Access Compliance Report Public Rights-of-Way (Curb Ramps)

Main Street: PERDIDO_ST Cross Street: BIENVILLE_AVE Location: NE

ADA ID: RPRK210924131615 Ramp Type: Type 1 - Perpendicular Diagonal Initial Pass/Fail: Fail Overall Compliance: No Severity Score: 45

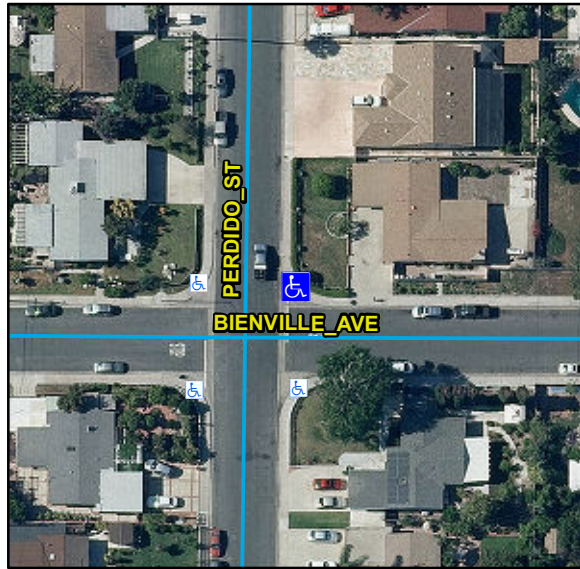
R304.2.2, R304.5.3, R302.7.2, STD 1115

Compliance	Description	Data	Compliance	Description	Data
N/A	Ramp Length (in)	50	N/A	Flare Type LT	
Yes	Ramp Width (in)	48			N/A
No	Ramp Run Slope (%)	15.5	N/A	Flare Slope LT (%)	N/A
No	Ramp Cross Slope (%)	5.4	N/A	Flare Traversable LT	N/A
N/A	Landing Present	N/A	N/A	Flare Type RT	
N/A	Landing Length (in)	N/A			N/A
N/A	Landing Width (in)	N/A	N/A	Flare Slope RT (%)	N/A
N/A	Landing Run Slope (%)	N/A	N/A	Flare Traversable RT	N/A
N/A	Landing Cross Slope (%)	N/A	N/A	DWS Provided	N/A
N/A	Landing Movement Obstructed?	N/A	N/A	DWS Contrast	N/A
	Landing Movement Type	N/A	N/A	DWS Length (in)	N/A
N/A	Landing Shared	N/A	N/A	DWS Full Width	N/A
N/A	Clear Space	Yes	N/A	DWS Offset Left (in)	N/A
N/A	Clear Space To Crosswalk (in)	N/A	N/A	DWS Offset Right (in)	N/A
N/A	Marked Crosswalk 1	No	N/A	Marked Crosswalk 2	No
	Crossing 1 Direction	W		Crossing 2 Direction	S
	Marked Crosswalk 1 Width (in)	N/A		Marked Crosswalk 2 Width (in)	N/A

N/A	Ramp Inside Crosswalk 1	N/A	Yes	Ramp Inside Crosswalk 2	N/A
	Crossing 1 Slope (%)	8.1		Crossing 2 Slope (%)	8.3
	Crossing 1 Cross Slope (%)	0.5		Crossing 2 Cross Slope (%)	0.2
N/A	Gutter Ponding	N/A	No	Curb Slope	5.5
No	Gutter Lip Height (in)	0.5		Road Run Slope (%)	0
N/A	Gutter Run Slope (%)	N/A		Road Cross Slope (%)	1.1
N/A	Gutter Cross Slope (%)	N/A			
Yes	Overall Surface Condition: Acceptable		Yes	Perp Joint Present	Yes
	Cross Gutter Present?	Yes		Spandrel Present?	Yes
	Replace Cross Gutter?	No		Replace Spandrel?	No

Remove & Replace Curb Ramp With Two New Directional Ramps or Equivalent.
